VCPS - New School

210 12th Street NE, Valley City, ND 58072
Project #: 24-028
Addendum 02
03/24/2026

E002 – SITE PLAN – ELECTRICAL

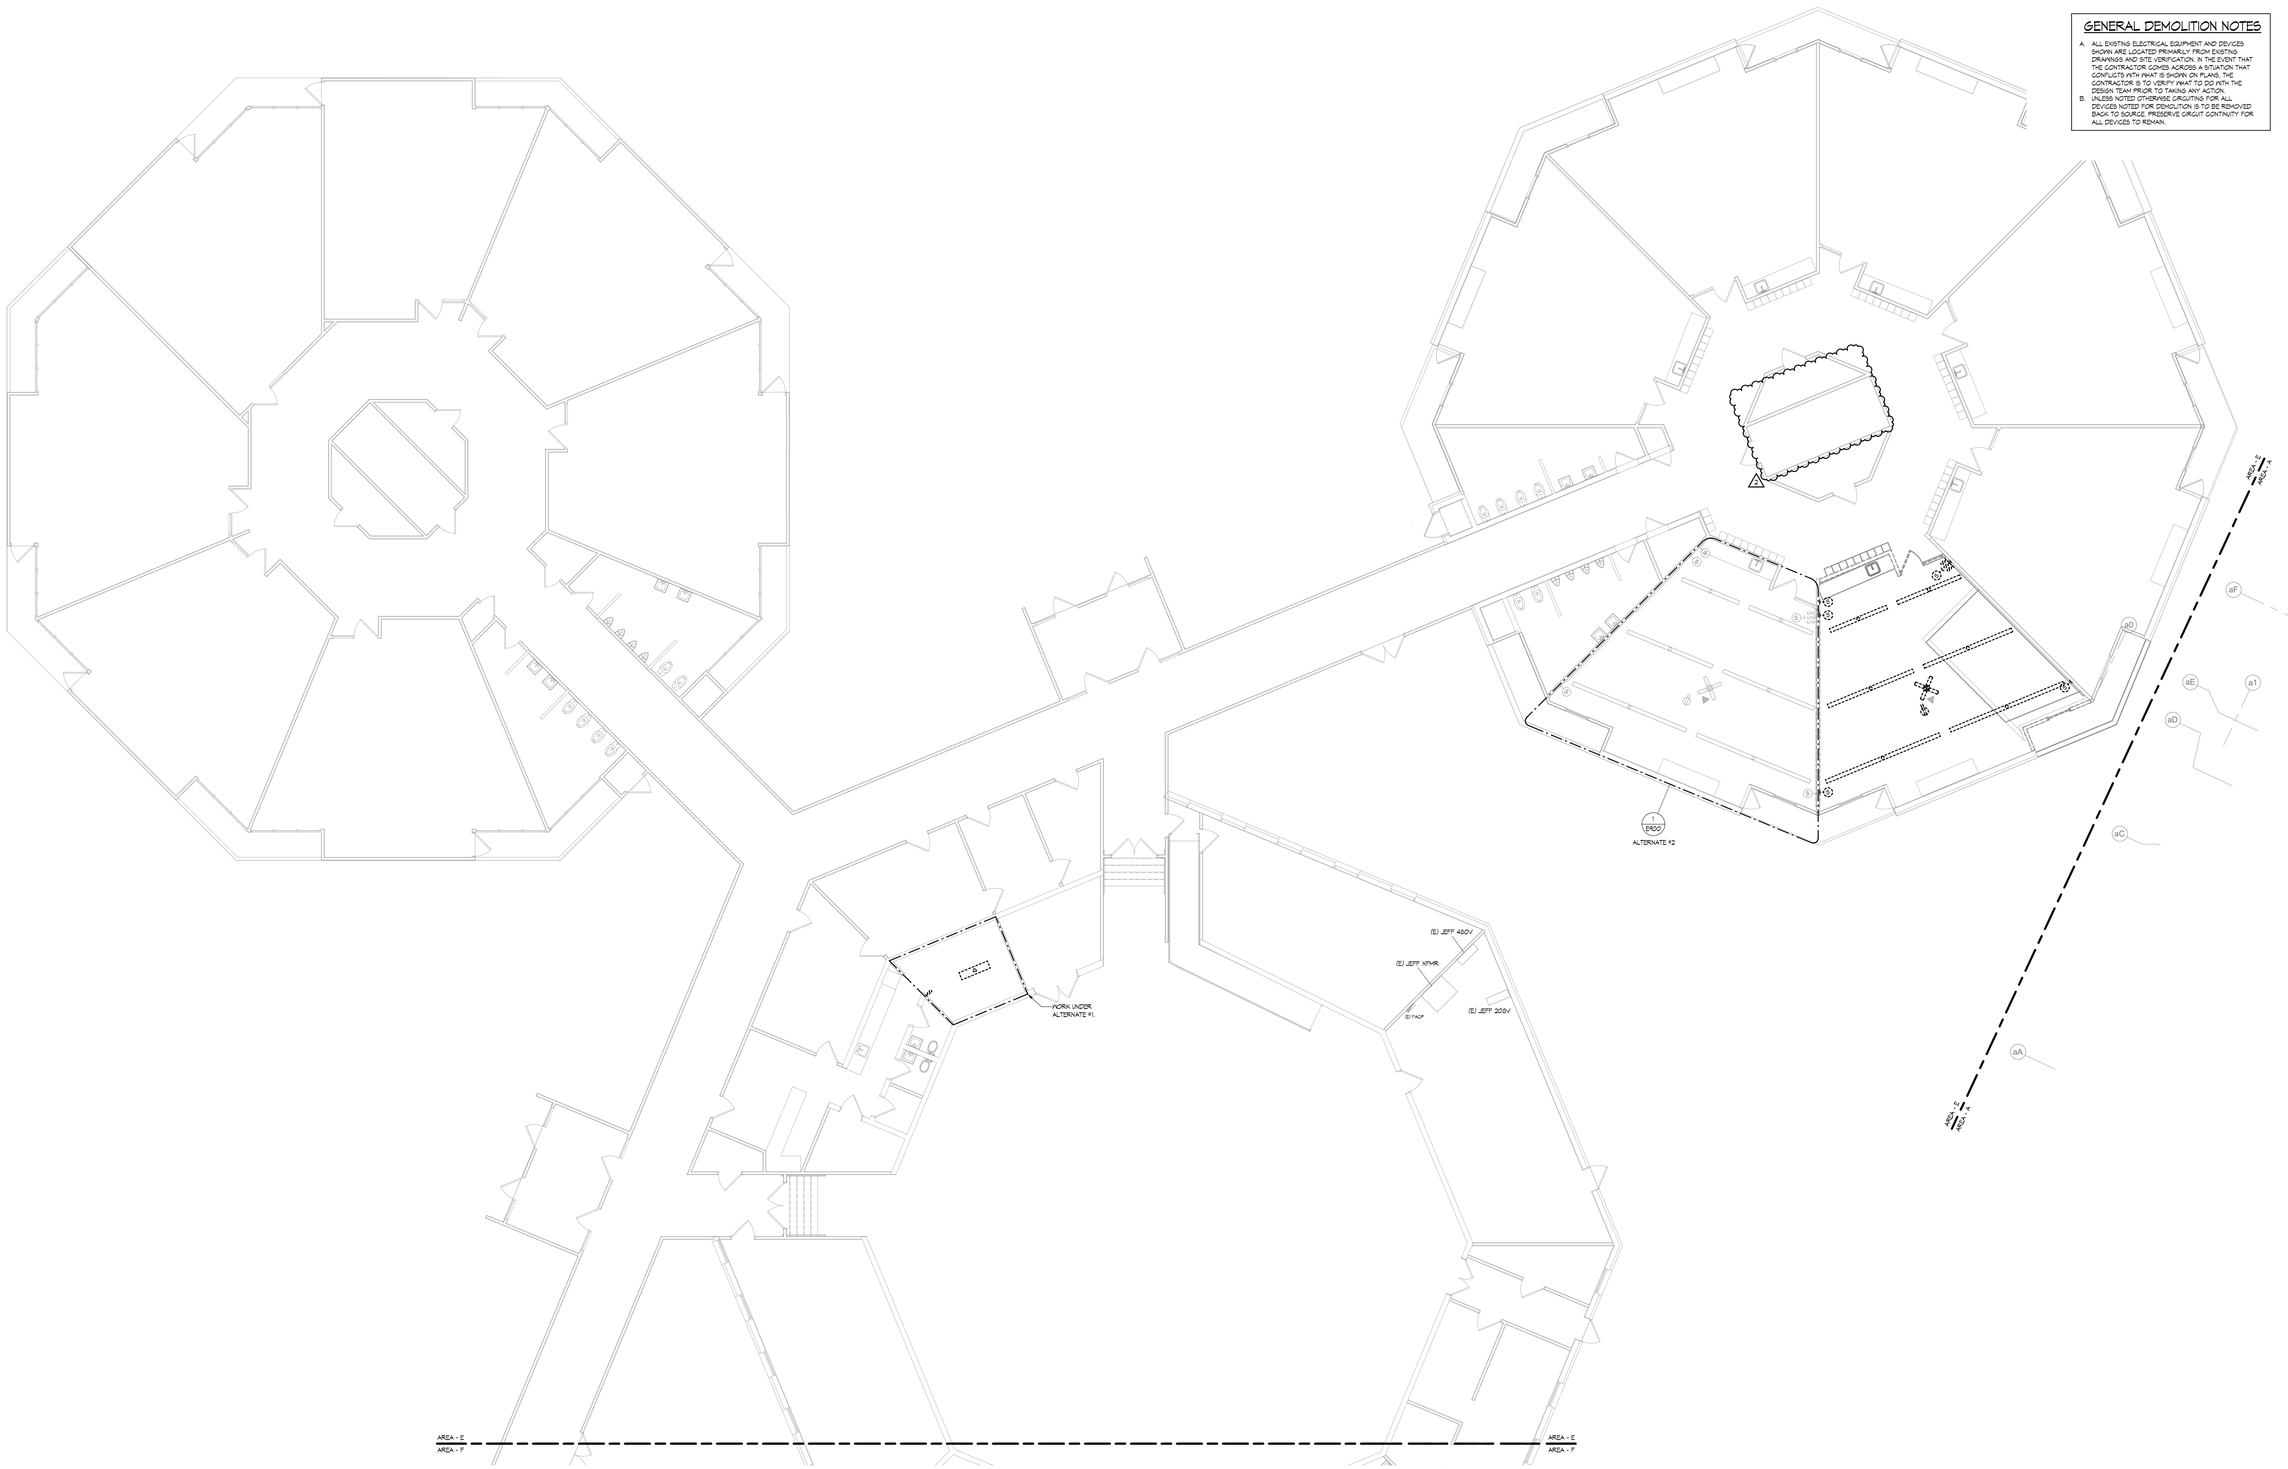
1. Added one (1) type AA2w fixture.
